DEVELOPMENT APPLICATION ASSESSMENT REPORT

Application Number:	DA2022/1490
----------------------------	-------------

Responsible Officer:	Alex Keller
Land to be developed (Address):	Lot 21B DP 395978, 28 Bangaroo Street NORTH BALGOWLAH NSW 2093
Proposed Development:	Demolition works and construction of a new dwelling house, swimming pool, secondary dwelling and retail shop/office premises
Zoning:	Warringah LEP2011 - Land zoned R2 Low Density Residential
Development Permissible:	No
Existing Use Rights:	Yes
Consent Authority:	Northern Beaches Council
Land and Environment Court Action:	Yes
Owner:	Z & C Investment Pty Ltd
Applicant:	Z & C Investment Pty Ltd

Image: Proposed setback position shown in context with new building footprint and landscape elements.

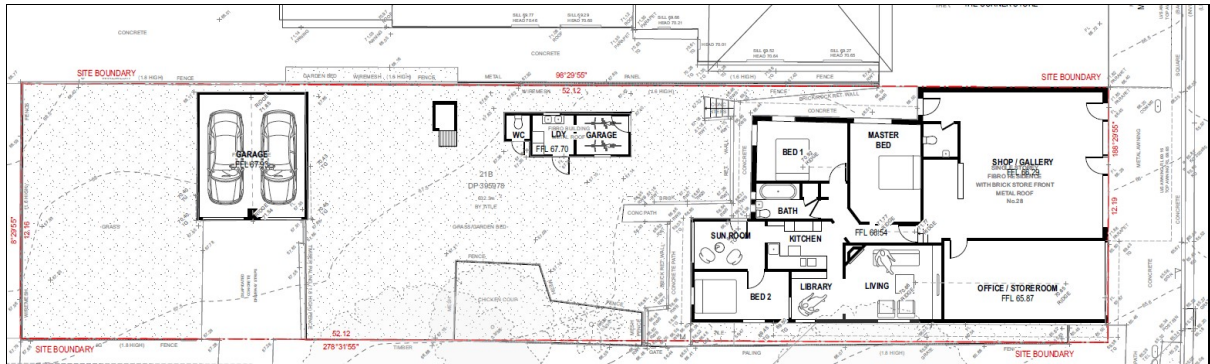
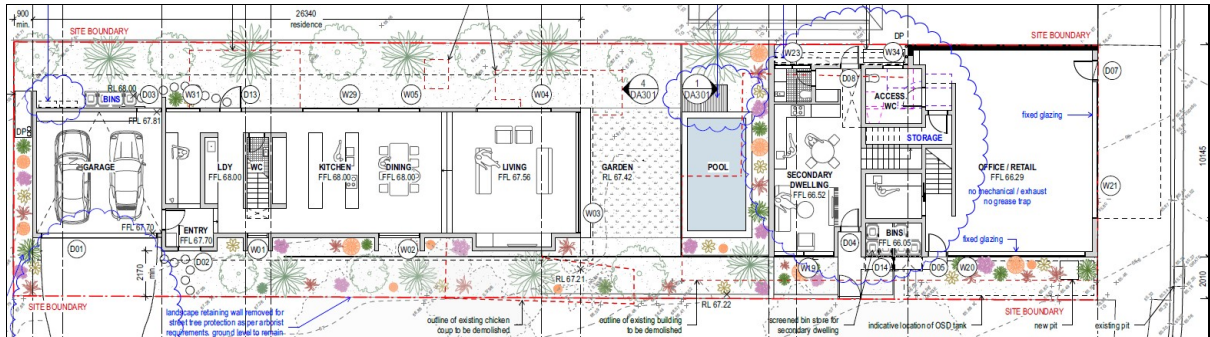
The non-compliance with the side setback does not create any unreasonable loss of opportunity for deep soil landscaping space. Generally landscaped open space is reduced by the new dwelling house on the site (this is addressed under Part D1 within this report). Landscape elements are still retained along the side setback to with No.30 Bangaroo Street and along the western boundary and along the front boundary. The site has 2 side boundaries and 2 front (street) boundaries and the positioning of the re-built shop component and secondary dwelling area retains a similar setback pattern. The site has existing use rights relating to the shop component and the use of nil setback is appropriate as shown on the amended plans (below) and does not unreasonably diminish deep soil areas

The overall bulk and scale of the building is has been amended and the roof profile reduced to minimise upper building bulk and provide a more 'compressed' scale for the house, and shop front component. In this regard the the proposed building seeks to a larger footprint, maintains a centralised position for the new detached house. The secondary dwelling and principal dwelling comply with the side setback. Overall adequate landscaping will be provided to ensure the building does not become excessively dominant compared to adjacent dwellings and landscaping elements have also been used at the upper storey to soften the building appearance.

Image: Overshadowing of site and surroundings 9am to 3pm on the 21 June.

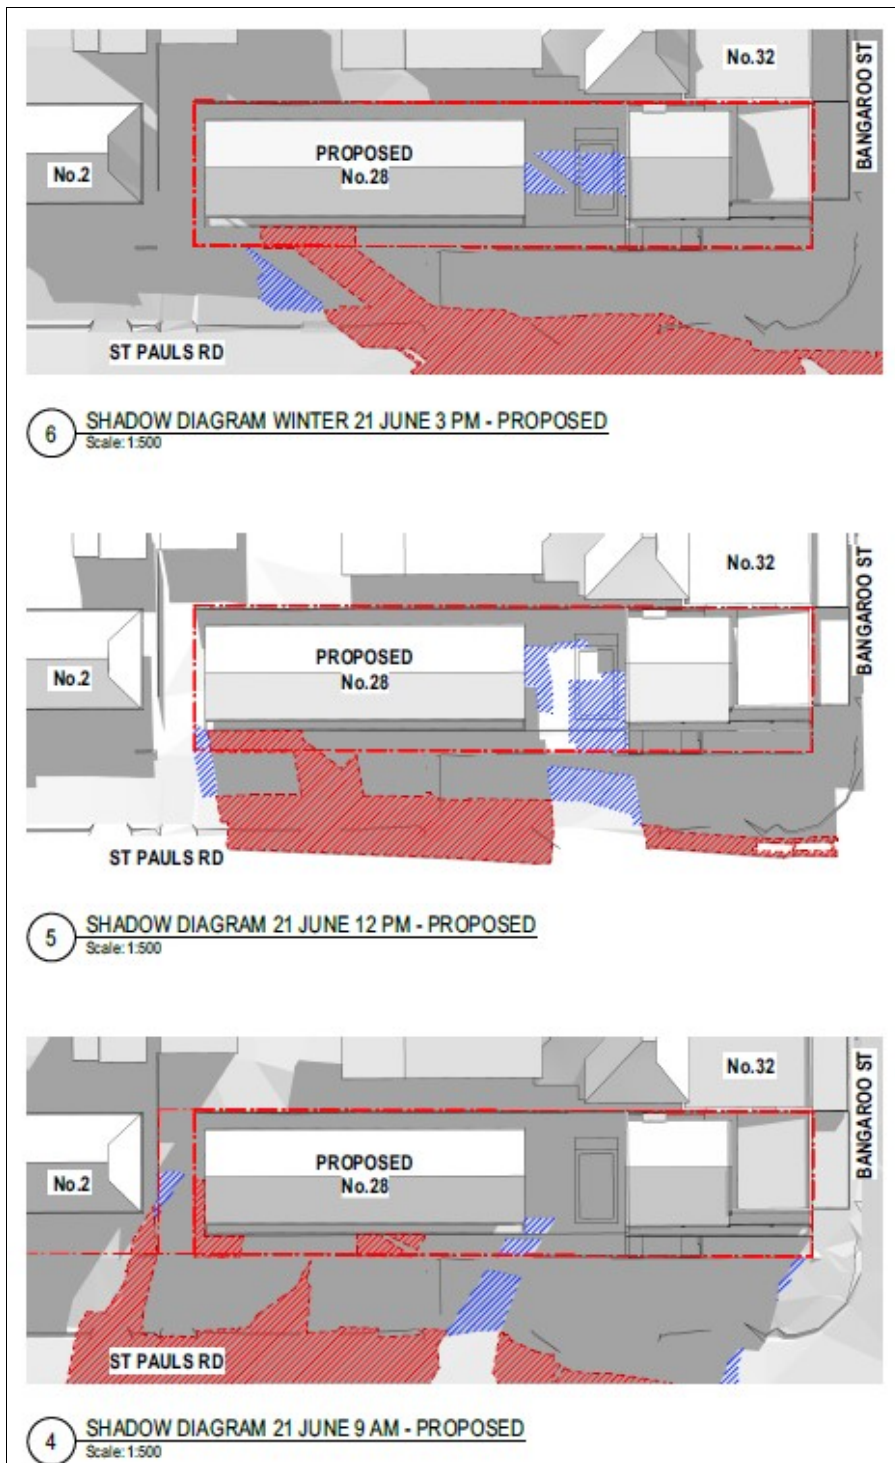
The subject building design has been amended to reduce upper bulk by lowering the roof apex which assists to reduce the overshadowing regime. The proposal demonstrates compliant In this regard access to sunlight is maintained to surrounding land. Shadow diagrams for 9am 12 midday and 3pm have been provided to show the solar impact of the proposal (dated 9.5.2023).

Images: Screening added with amended elevations for privacy and screening at upper storey.

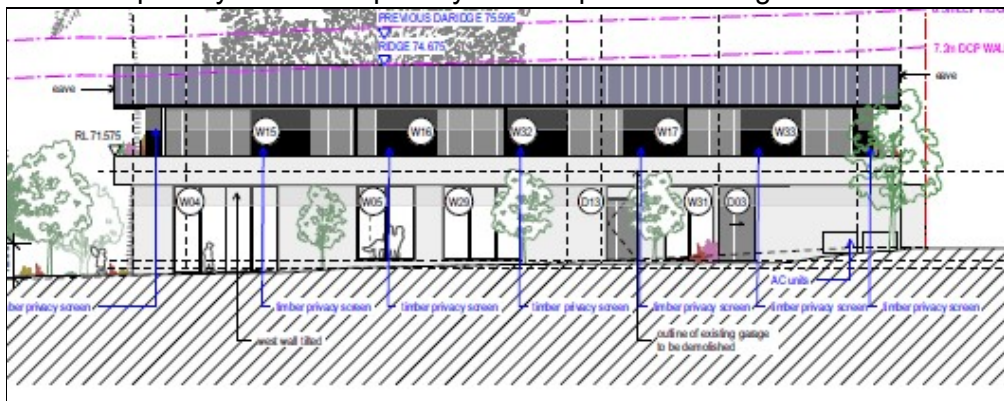
The proposal generally concentrates private open space areas toward the middle of the site and uses window screens for the upper storey of the dwelling along the northern elevation and translucent (fluted) glass to the western terrace (glazed) door. At ground level standard height fencing and boundary screen planting provides suitable screening and privacy protection.
